SERVICE BULLETIN

N° **189-291**

ATA 25 - LOWER WIRE STRIKE PROTECTION SYSTEM KIT INSTALLATION

This Service Bulletin is issued in order to provide the necessary instructions on how to install the “kit lower wirestrike protection system” P/N 8G9540F00211.

Figure 1

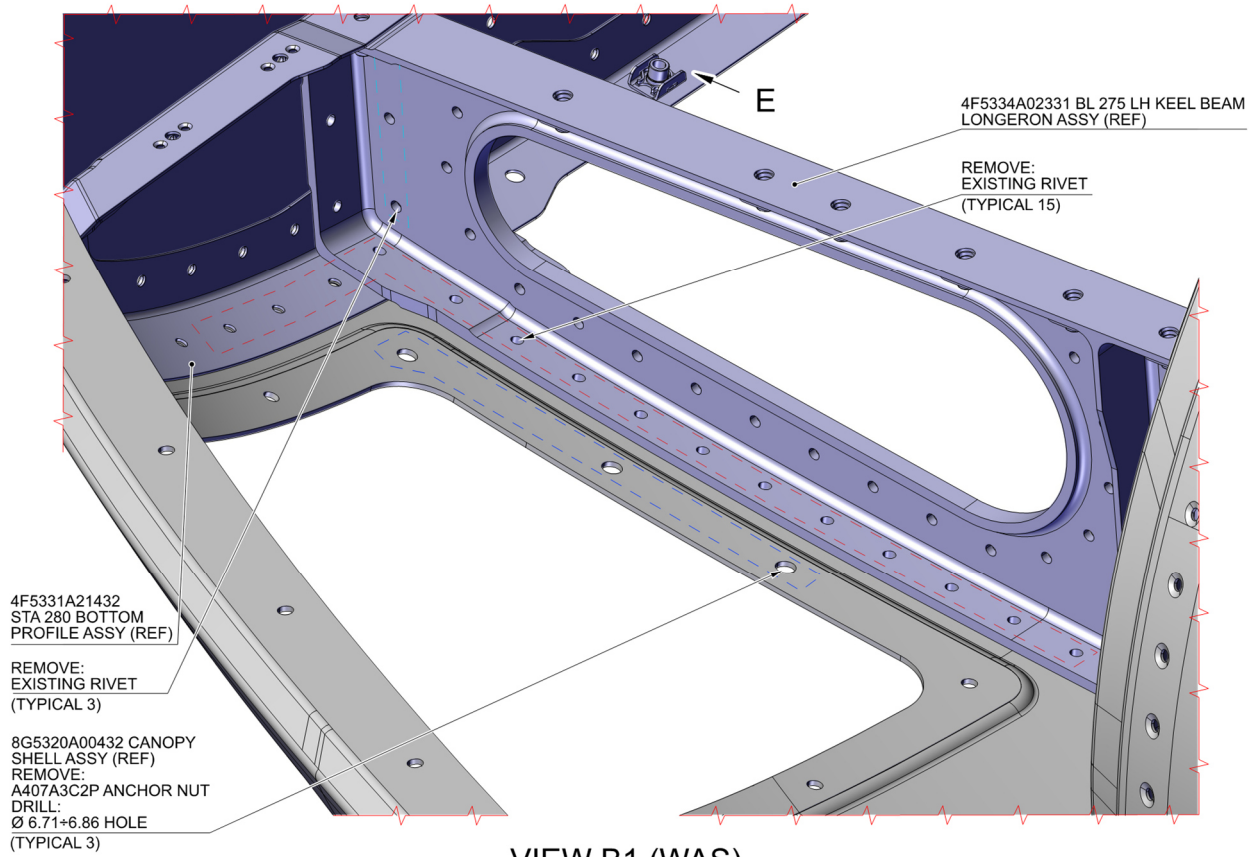
- 2.12 With reference to Figure 1 View A1 and View A2, countersink n°10 existing holes on the canopy shell assy P/N 8G5320A00432 to $\varnothing 8.46$ 100°.

- 2.13 With reference to Figure 1 View A1 and View A2, countersink n°2 existing holes on the canopy shell assy P/N 8G5320A00432 to $\varnothing 6.26$ 100°.

- 2.14 With reference to Figure 1 View A1, increase the diameter of n°3 existing holes on the “access panel assy” LH P/N 8G5320A12331 to $\varnothing 6.71 \pm 6.86$.

- 2.15 With reference to Figure 1 View A2 remove and discard n°1 screw P/N A428AC10 and n°2 screws P/N A428AC12 from the “mounting flange assy MWR/RWR FWD LH” P/N 8G9930A01131 and packer P/N 8G9930A01951.

- 2.16 With reference to Figure 1 View A2, increase the diameter of n°2 existing hole on the mounting flange assy MWR/RWR FWD LH P/N 8G9930A01131 and on the “EMC filter bonded assy” LH P/N 8G9930A04731 to \varnothing 6.71÷6.86.

- 2.17 With reference to Figure 1 View A2, increase the diameter of n°3 existing holes on the packer P/N 8G9930A01951 to \varnothing 6.71÷6.86.
- 2.18 With reference to Figure 5 View C2 (BECOMES), temporarily locate the fitting inboard P/N 8G9540A02251 on the panel assy P/N 4F5331A65634 and on the BL 275 LH keel beam longeron assy P/N 4F5334A02331, and countermark n°50 holes positions.

Figure 2

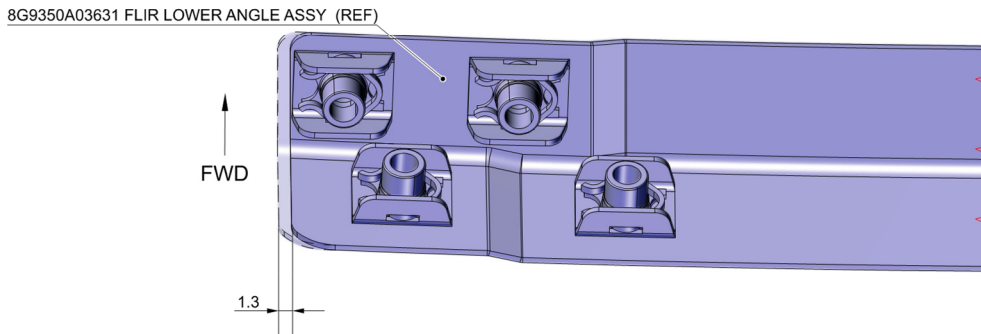
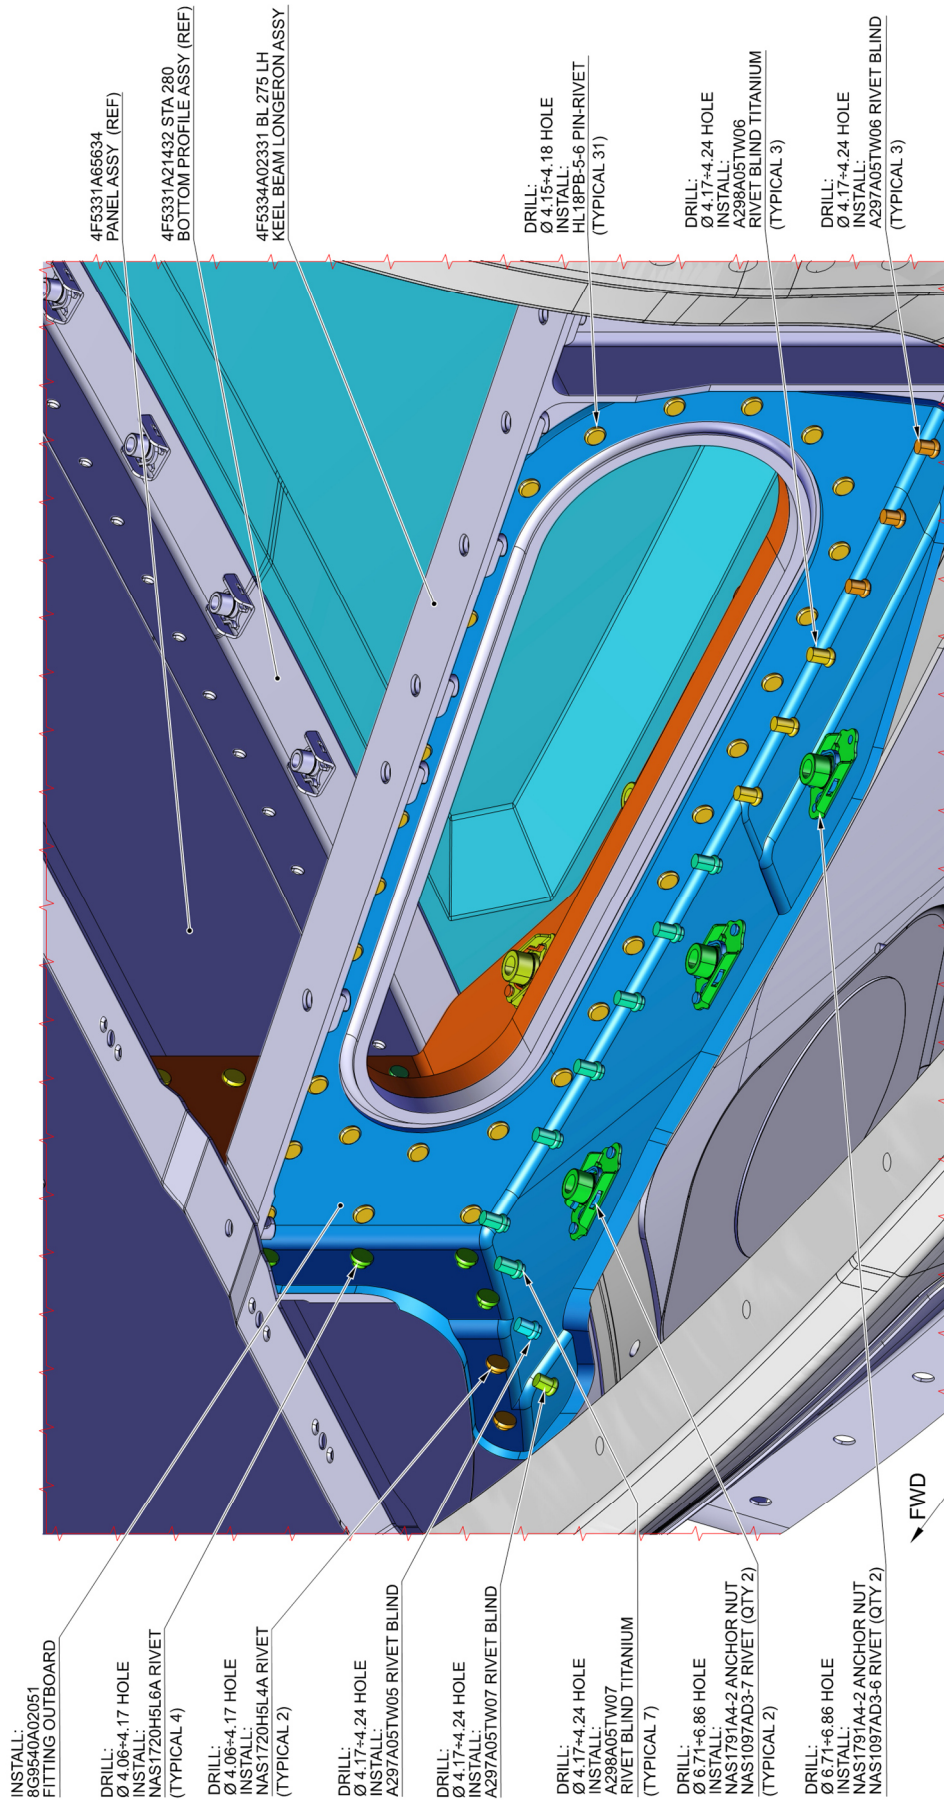
- 2.6 With reference to Figure 2 View E trim the “FLIR lower angle assy” P/N 8G9350A03631 in accordance with dimensions shown.
- 2.7 With reference to Figure 5 View C2 (BECOMES), replace the “FWD lower panel assy” P/N 8G5331P06031 with the “FWD lower panel assy” P/N 8G9540A02631. Fix it by means the existing hardware.

- 2.9 With reference to Figure 2 View B1 (WAS), remove and discard n°3 existing anchor nuts P/N A407A3C2P from canopy shell assy P/N 8G5320A00432.
- 2.10 With reference to Figure 2 View B1 (WAS), increase the diameter of n°3 existing holes on the canopy shell assy P/N 8G5320A00432 to $\varnothing 6.71 \pm 6.86$.

- 2.11 With reference to Figure 2 View B1 (WAS), remove n°15 existing rivets from the “BL 275 LH keel beam longeron assy” P/N 4F5334A02331 and “STA 280 bottom profile assy” P/N 4F5331A21432.

Figure 3

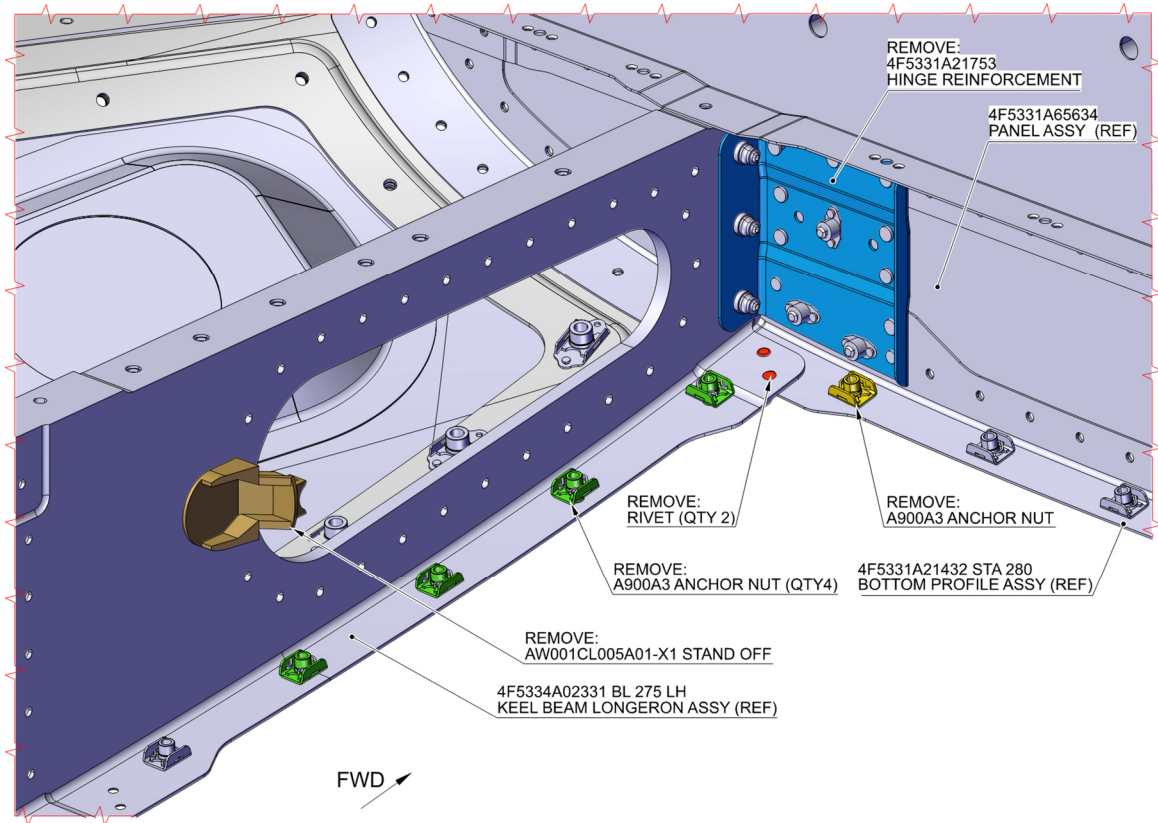
- 2.23 With reference to Figure 3 View B2 (BECOMES), temporarily locate the fitting outboard P/N 8G9540A02051 on the panel assy P/N 4F5331A65634 and on the BL 275 LH keel beam longeron assy P/N 4F5334A02331, and countermark n°52 holes positions.

- 2.24 With reference to Figure 3 View B2 (BECOMES), drill n°6 holes \varnothing 4.06÷4.17 and n°15 holes \varnothing 4.17÷4.24 thru the fitting outboard P/N 8G9540A02051.

- 2.26 With reference to Figure 3 View B2 (BECOMES), drill n°3 holes \varnothing 6.71÷6.86 thru

the fitting outboard P/N 8G9540A02051.

- 2.27 With reference to Figure 3 View B2 (BECOMES), install on the fitting outboard P/N 8G9540A02051 n°3 anchor nuts P/N NAS1791A4-2 by means of n°4 rivets P/N NAS1097AD3-7 and n°2 rivets P/N NAS1097AD3-6.

- 2.32 With reference to Figure 3 View B2 (BECOMES), install fitting outboard P/N 8G9540A02051 on the BL 275 LH keel beam longeron assy P/N 4F5334A02331 and on the bottom profile assy P/N 4F5331A21432, by means of n°7 rivets blind titanium P/N A298A05TW07, n°1 rivet blind P/N A297A05TW07, n°1 rivet blind P/N A297A05TW05, n°3 rivet blind titanium P/N A298A05TW06 and n°3 rivet blind P/N A297A05TW06.

- 2.33 With reference to Figure 3 View B2 (BECOMES), fix the fitting outboard P/N 8G9540A02051 on the STA 280 bottom profile assy P/N 4F5331A21432 and on the panel assy P/N 4F5331A65634 by means of n°4 rivets P/N NAS1720H5L6A and n°2 rivets P/N NAS1720H5L4A.

Figure 4

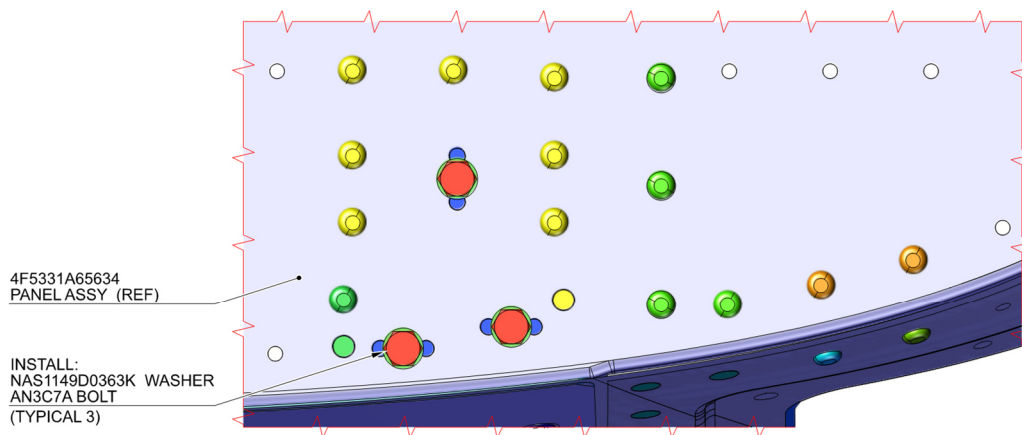
- 2.1 With reference to Figure 4 View C1 (WAS), remove and discard n°4 existing anchor nuts P/N A900A3 from “BL 275 LH keel beam longeron assy” P/N 4F5334A02331.
- 2.2 In accordance with applicable steps of DM 89-A-52-41-01-00A-520A-A, remove the radome hinge P/N 4F5331A58452 from the “hinge rear reinforcement LH” P/N 4F5331A21753.
- 2.3 With reference to Figure 4 View C1 (WAS), remove and discard the hinge rear reinforcement LH P/N 4F5331A21753 from “STA 280 bottom profile assy” P/N 4F5331A21432 and the panel assy P/N 4F5331A65634.
- 2.4 With reference to Figure 4 View C1 (WAS), remove and discard n°1 anchor nut P/N A900A3 from “STA 280 bottom profile assy” P/N 4F5331A21432.

- 2.5 With reference to Figure 4 View C1 (WAS), remove and discard the stand off P/N AW001CL005A01-X1 from the “BL 275 LH keel beam longeron assy” P/N 4F5334A02331.

- 2.31 With reference to Figure 4 View D, fix the radome hinge P/N 4F5331A58452 to the panel assy P/N 4F5331A65634 by means of n°3 washers P/N NAS1149D0363K and n°3 bolts P/N AN3C7A.

Figure 5

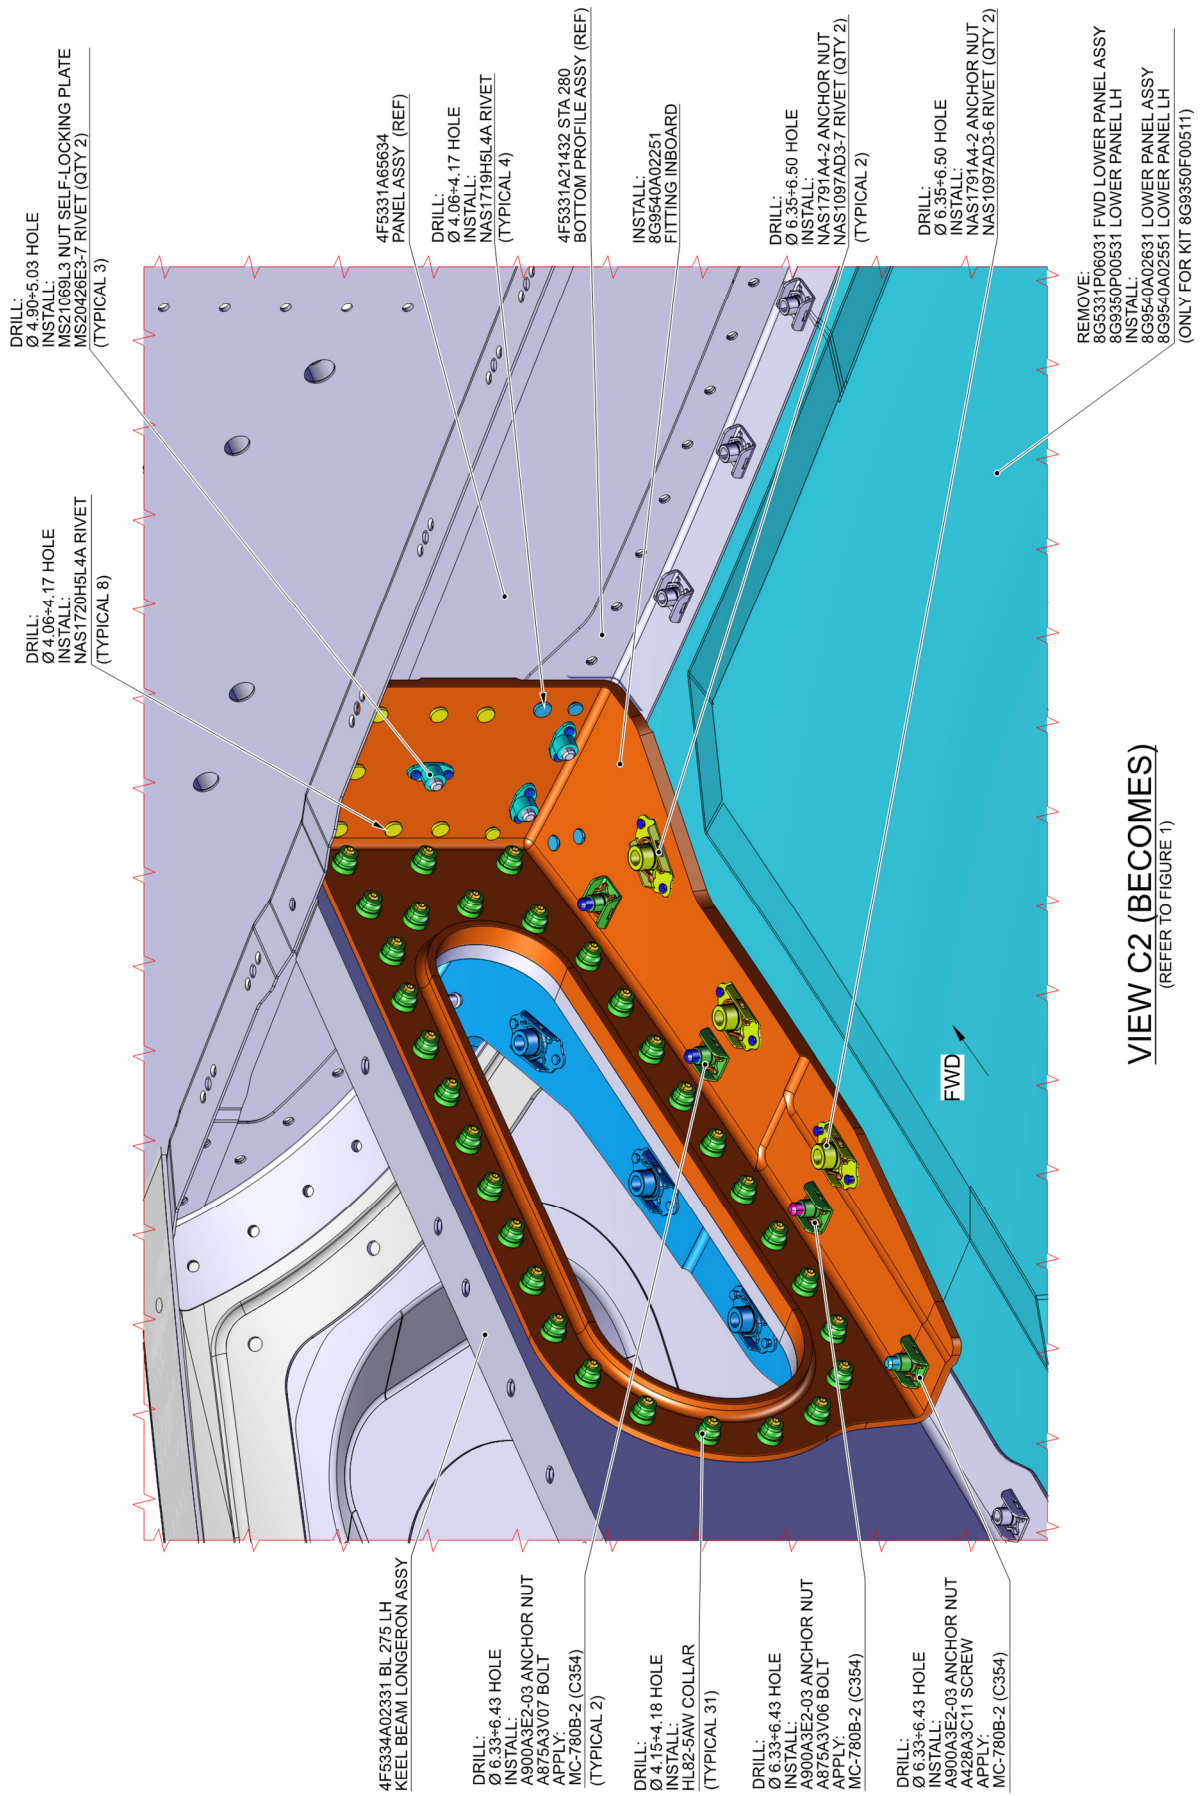
- 2.8 With reference to Figure 5 View C2 (BECOMES), replace the “lower panel LH” P/N 8G9350P00531 with the lower panel LH P/N 8G9540A02551. Fix it by means the existing hardware. Discard the 5 existing panel screws P/N A428AC09 in excess.

- 2.19 With reference to Figure 5 View C2 (BECOMES), drill n°3 holes \varnothing 4.90÷5.03, n° 12 holes \varnothing 4.06÷4.17 and n°4 holes \varnothing 6.33÷6.43 thru the fitting inboard P/N 8G9540A02251.

- 2.20 With reference to Figure 5 View C2 (BECOMES), drill n°3 holes \varnothing 6.35÷6.50 thru the fitting inboard P/N 8G9540A02251.
- 2.21 With reference to Figure 5 View C2 (BECOMES), install on the fitting inboard P/N 8G9540A02251 n°4 anchor nuts P/N A900A3E2-03 by means of sealant MC-780 C2 (C354).

- 2.22 With reference to Figure 5 View C2 (BECOMES), install on the fitting inboard P/N 8G9540A02251 n°3 anchor nuts P/N NAS1791A4-2 by means of n°4 rivets P/N NAS1097AD3-7 and n°2 rivets P/N NAS1097AD3-6.

- 2.28 With reference to Figure 5 View C2 (BECOMES), install the fitting inboard P/N 8G9540A02251 on the “BL 275 LH keel beam longeron assy” P/N 4F5334A02331 by means of n°1 screw P/N A428A3C11, n°1 bolt P/N A875A3V06, n°2 bolts P/N A875A3V07 and n°2 rivets P/N NAS1719H5L4A.

- 2.29 With reference to Figure 5 View C2 (BECOMES), fix the fitting inboard P/N 8G9540A02251 on the STA 280 bottom profile assy P/N 4F5331A21432 and on the panel assy P/N 4F5331A65634 by means of n°8 rivets P/N NAS1720H5L4A and n°2 rivets P/N NAS1719H5L4A.

- 2.30 With reference to Figure 5 View C2 (BECOMES), install on the fitting inboard P/N 8G9540A02251 n°3 nut self-locking plates P/N MS21069L3 by means of n°6 rivets P/N MS20426E3-7.

Figure 6

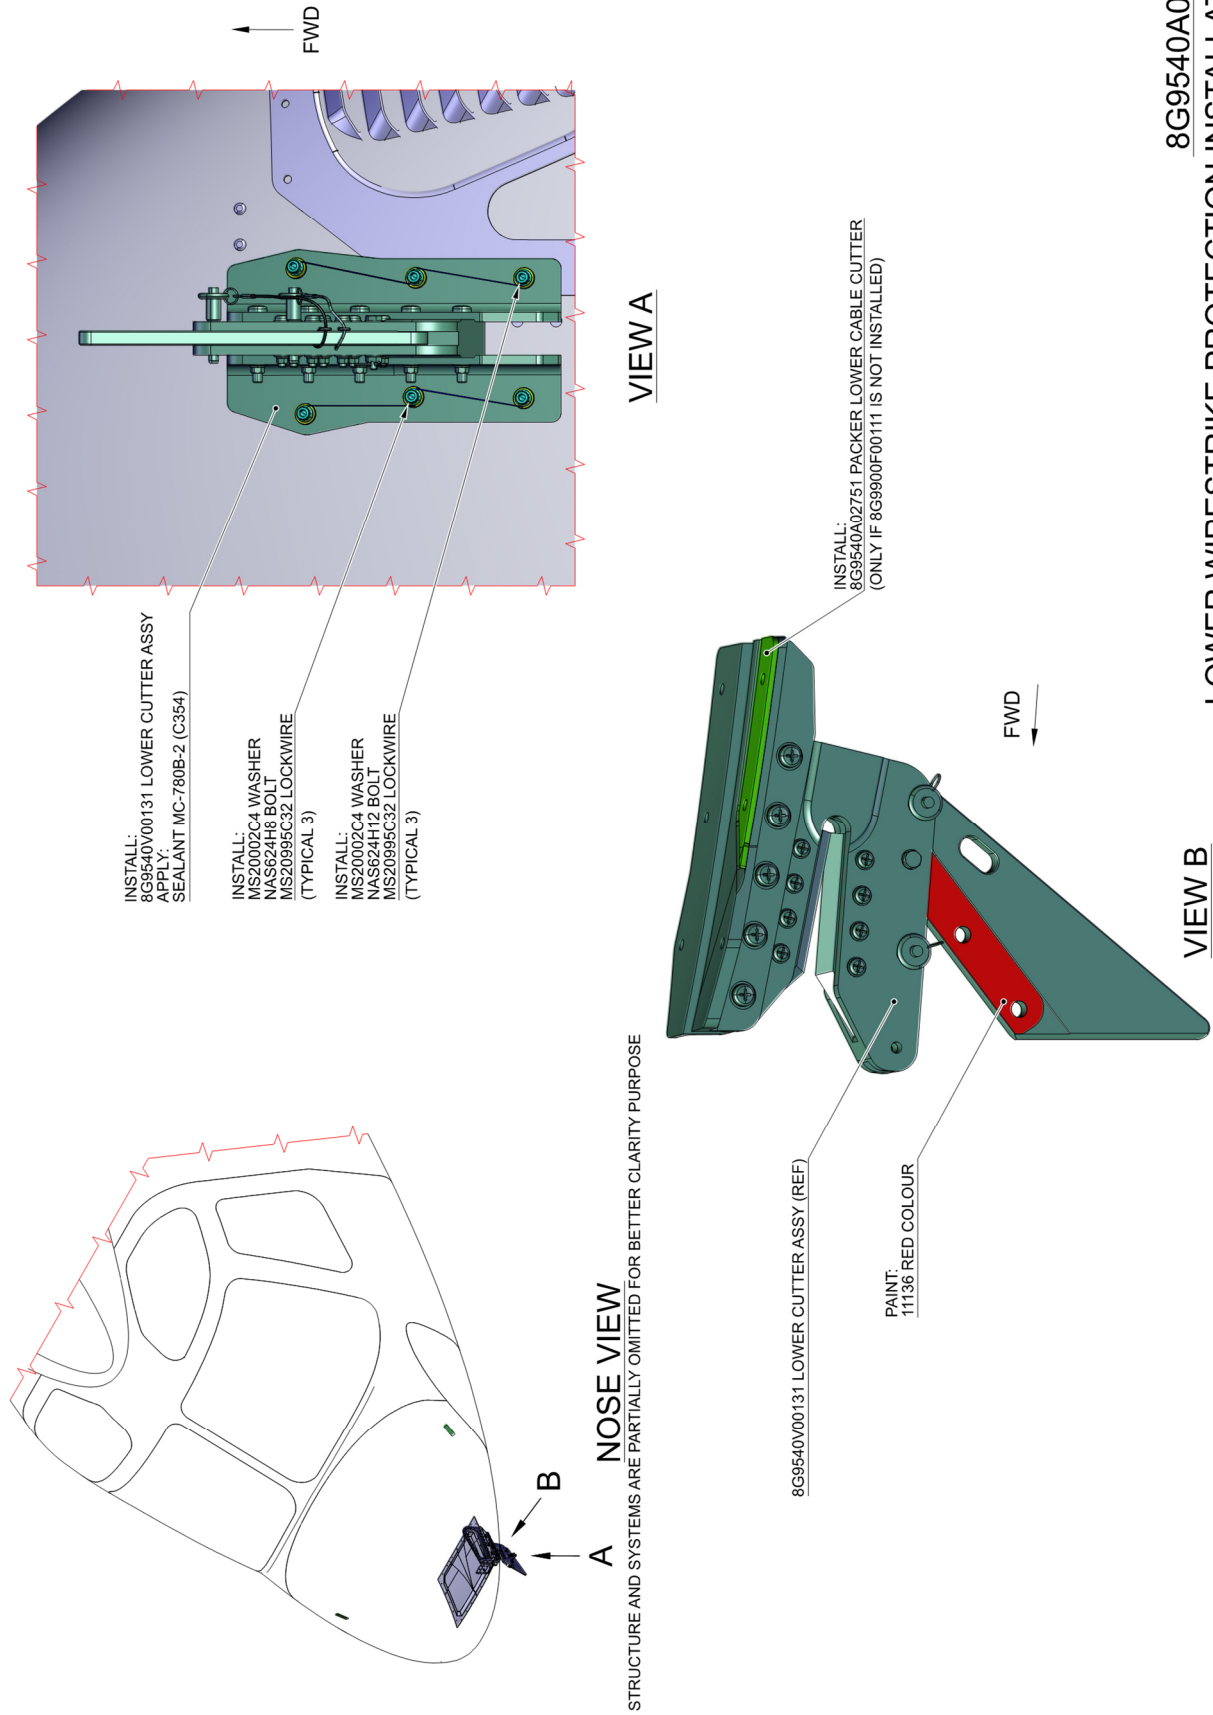
- 2.2 With reference to Figure 6 View A and View B, install the “lower cutter assy” P/N 8G9540V00131 and the “packer lower cable cutter” P/N 8G9540A02751 on the fuselage by means of n°6 washers P/N MS20002C4, n°3 bolts P/N NAS624H12 and n°3 bolts P/N NAS624H8. Safety the six bolts by means of lockwire P/N MS20995C32. Torque the fixing hardware to 6.32 thru 8.92 Nm.

- 2.3 With reference to Figure 6 View A, install the lower cutter assy P/N 8G9540V00131 on the fuselage by means of n°6 washers P/N MS20002C4, n°3 bolts P/N NAS624H12 and n°3 bolts P/N NAS624H8. Safety the six bolts by means of lockwire P/N MS20995C32. Torque the fixing hardware to 6.32 thru 8.92 Nm.
- 2.4 With reference to Figure 6 View A, apply sealant MC-780 C2 (C354) all around the

edge of the lower cutter assy P/N 8G9540V00131 at the interface with the fuselage only.

- 2.5 With reference to Figure 6 View B, paint the indicated surface with 11136 red colour.
3. With reference to Figure 7, perform “Markings Lower Wire Strike” P/N 8G1120A18311 as described in the following procedure:
 - 3.1 In accordance with DM 89-A-11-00-01-00A-720A-A and with reference to Figure 7, apply n°2 decals P/N AW003DBHC023E08I in indicated positions.
4. In accordance with weight and balance changes, update the Chart A (see Rotorcraft Flight Manual, Part II, section 6).
5. Return the helicopter to flight configuration and record for compliance with Part II of this Service Bulletin on the helicopter logbook.
6. Gain access to My Communications section on Leonardo WebPortal and compile the “Service Bulletin Application Communication”.
